# CERN RTD positions on LMQXFA01

R. Bossert, F. Nobrega, S.  
Feher, L. Martin, T. Strauss

9/12/24

**Plan view (view from above) with CERN desired layout of Q1/Q3**

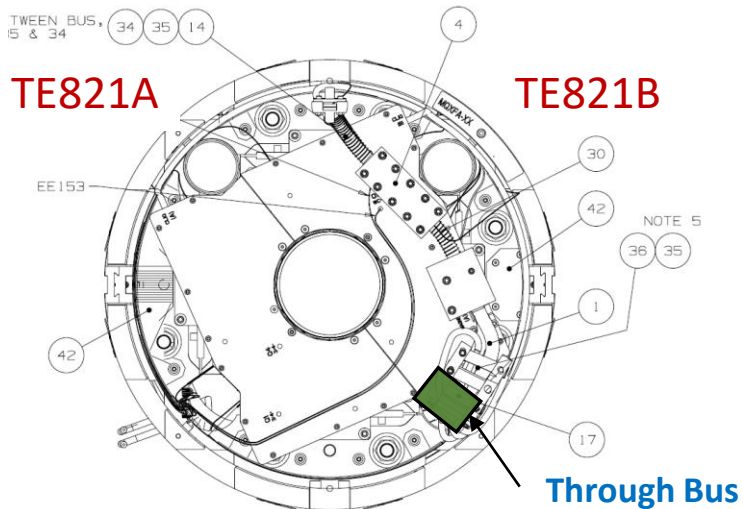
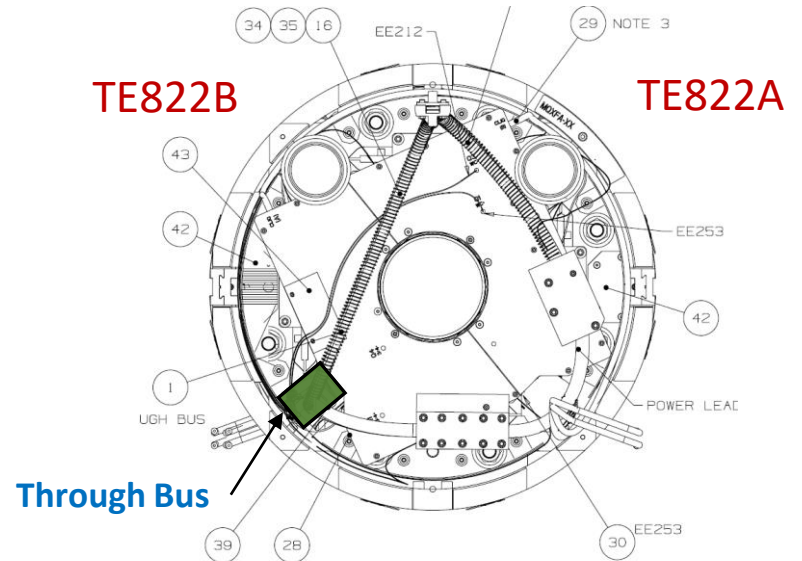
*As we believe installed on CA01*

We found one problem when the spreadsheet was created, it should be an issue on the Qa end for CA01. We noticed that in the assignment we mixed up the Pin1 TE821A & Pin 2 TE821B assignment.

We also note that there is an indication the sensor on the Qb end are swapped, they are really close in value and on the CERN sheet moved opposite in value. We can see from our cold data a small offset between the two values

Cover Flange 48HV-4LV 1 T  
Q1A - Q3A  
Top View

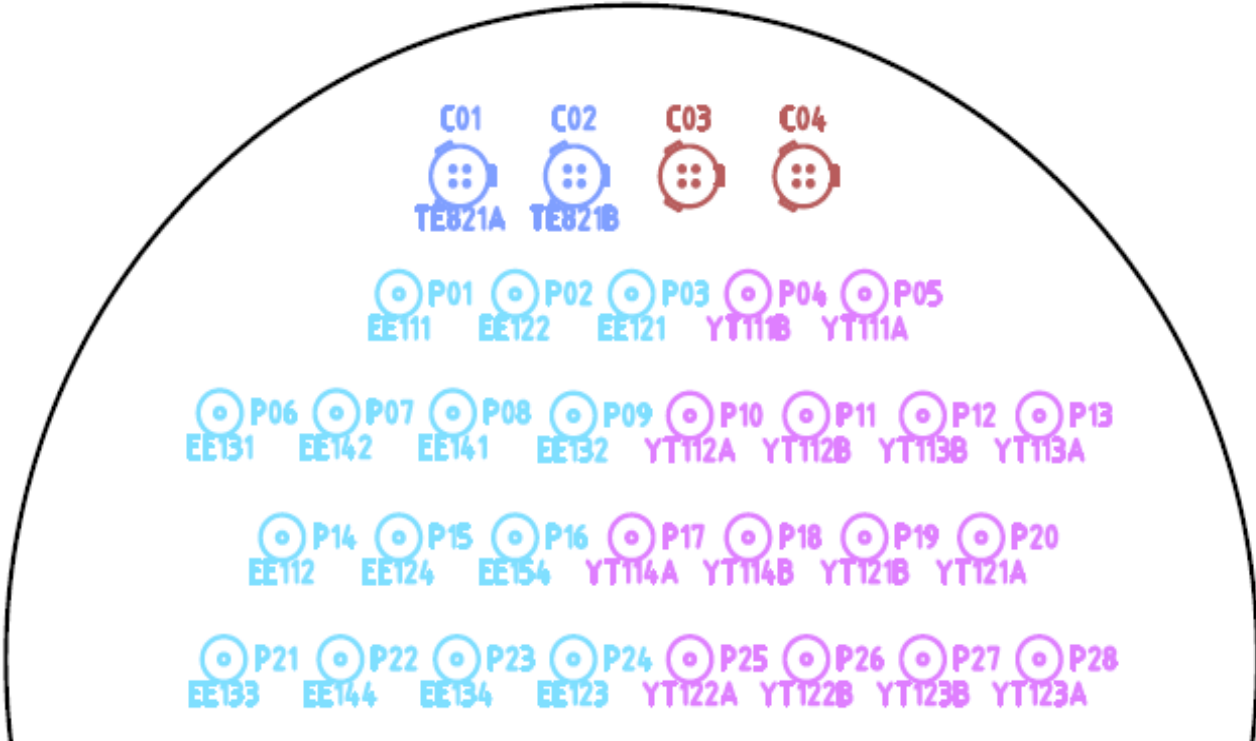
- We might have the CERNOX location on the assembly wiring reversed from the expectation to CERN
- We implement edchanges for CM & CA assembly to prevent this in the future (excl. CA02, which is completed and from data shows the first issue persisted)
